**UNITED STATES
NUCLEAR REGULATORY COMMISSION**

**SUBJECT: BYRON UNIT 2 - NRC SPECIAL INSPECTION TEAM (SIT)
REPORT 05000455/2012008**

Report No.: 05000455/2012008

Facility: Byron Station, Unit 2

Description of Unit 2 SR 4kV Bus 241 and Bus 242 Undervoltage Protection Scheme (Figure 2)

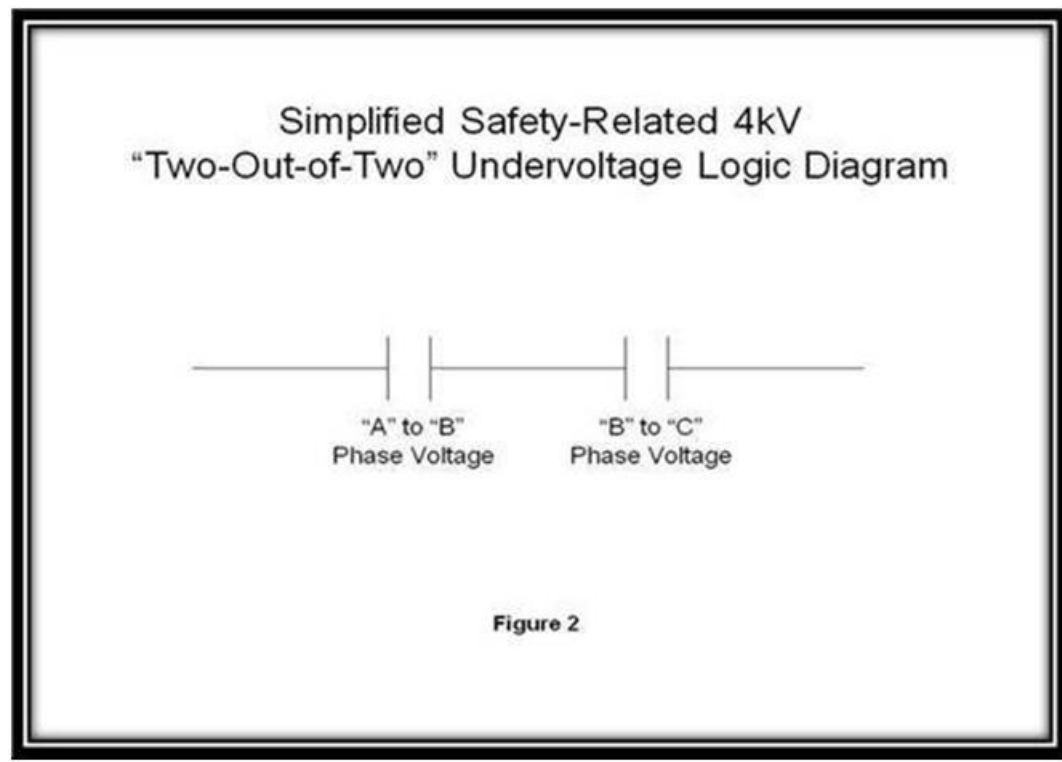
Introduction: The inspectors identified an unresolved item (URI) pending a determination of whether the undervoltage protection design vulnerability revealed by the loss of the single phase event was within the station's current licensing basis (CLB).

Description: TS 3.3.5, "Loss of Power (LOP) DG Start Instrumentation," required that in Modes 1-4 two channels per bus of the loss of voltage (undervoltage) function and two channels per bus of the degraded voltage function shall be operable. In addition, Technical Specification Surveillance Requirement (TSSR) 3.3.5.2 stated that the acceptable channel calibration values for the undervoltage setpoint was greater than 2730Vac, with a time delay of less than or equal to 1.9 seconds; and for the degraded voltage setpoint, the value was greater than 3930Vac with a time delay of 310 plus or minus 30 seconds. Upon actuation of the undervoltage or degraded voltage function, the DGs were designed to start and provide power to all ESF loads.

However, because the ESF undervoltage and degraded voltage protection schemes were comprised of two contacts in series that monitored differential voltages between the A-B and B-C phases, upon the loss of only the "A" or "C" phase, only one protective relay is actuated and therefore does not satisfy the coincidence logic necessary to initiate an undervoltage or degraded voltage protection signal.

At the end of this inspection, a detailed NRC review of the CLB was in progress. This URI will remain open pending the completion of this review and a determination of whether the undervoltage and degraded voltage protection design vulnerability was within the station's CLB. **(URI 05000454/2012008-001, 05000455/2012008-001, Inadequate Undervoltage Protection)**
